Service Bulletin

Bulletin No.: 13-06-01-003F

Subject: Excessive Oil Consumption – Perform Oil Consumption Test and/or Install Piston and Piston Ring Kit

Models: 2010-2013 Buick LaCrosse
2011-2013 Buick Regal
2012-2013 Buick Verano
2010-2013 Chevrolet Equinox
2012-2013 Chevrolet Captiva, Orlando (Canada Only)
2010-2013 GMC Terrain
Equipped with 2.4L Engine (RPOs LAF, LEA)

Acceptable Cylinder that Does Not Appear Uniform (Zebra Stripes)

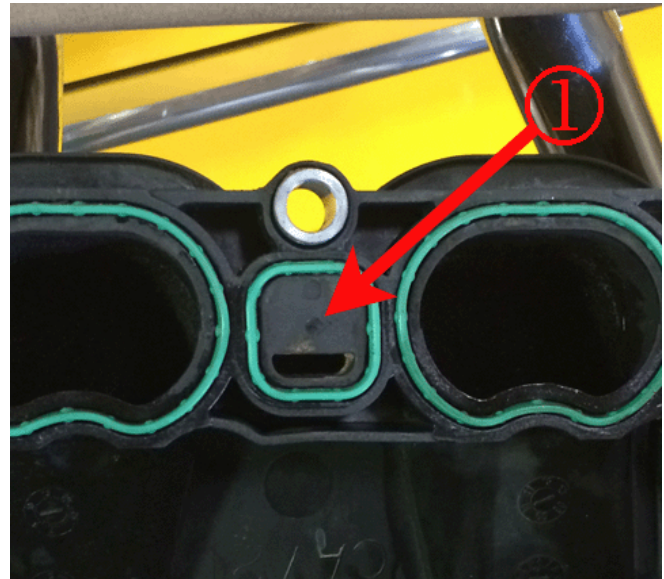
The repair is to replace the pistons and rings. In some cases the bore surface may not have a uniform look to the finish (zebra stripes) as shown below. As a result, some technicians may question whether the engine should be repaired or replaced. After careful evaluation, GM Powertrain has determined that the new pistons and rings will perform correctly in bores that have this appearance so engine replacement should not be necessary. The cylinder bores do not need any machine or honing work performed on them. Refer to the picture below for acceptable surface finishes.

- (1) PCV orifice in the intake manifold

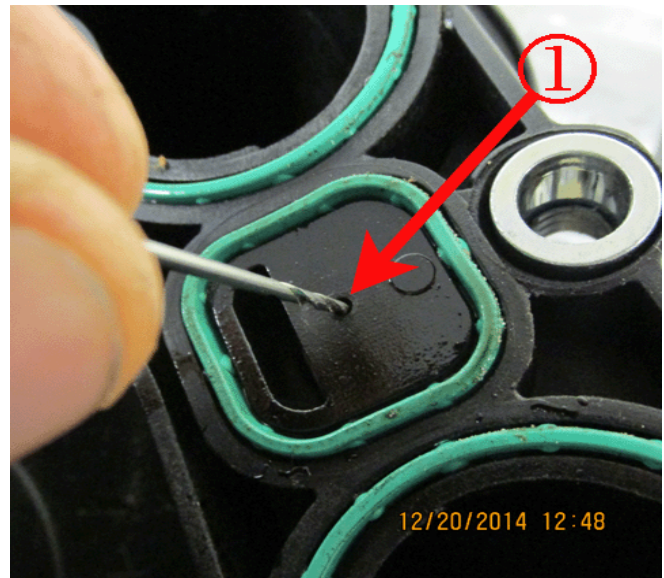
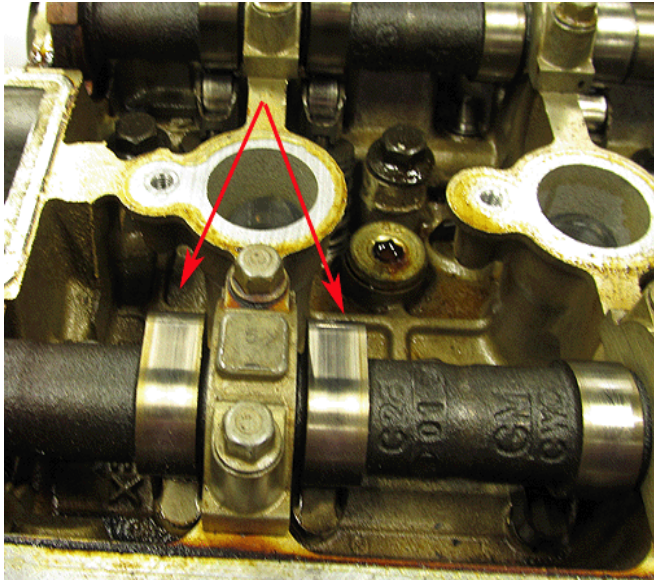
The oil consumption may have clogged/ reduced PCV flow. The PCV system should be serviced.

Clean any ice/sludge/water/carbon out of the PCV pipes/hoses, the PCV nipple on the cam cover, the PCV orifice between the #2 and #3 intake runners (use a 1/16 inch drill bit as illustrated below).

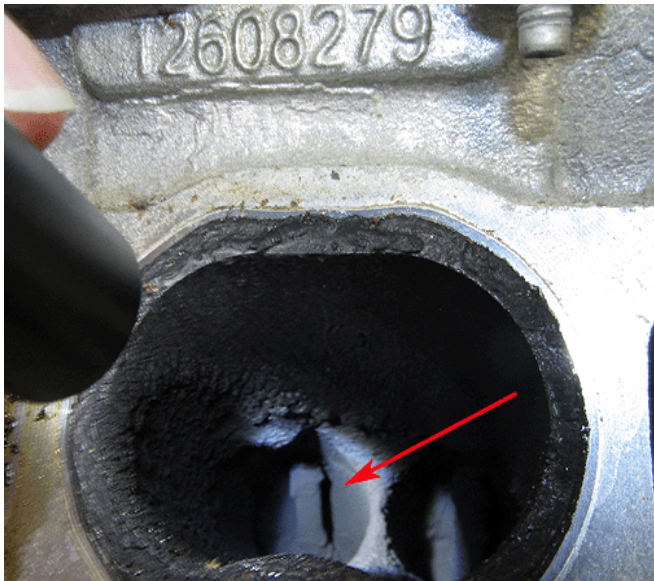
- Camshafts and roller follower will have wear markings. This is normal and do not need to be replaced (refer to picture above).
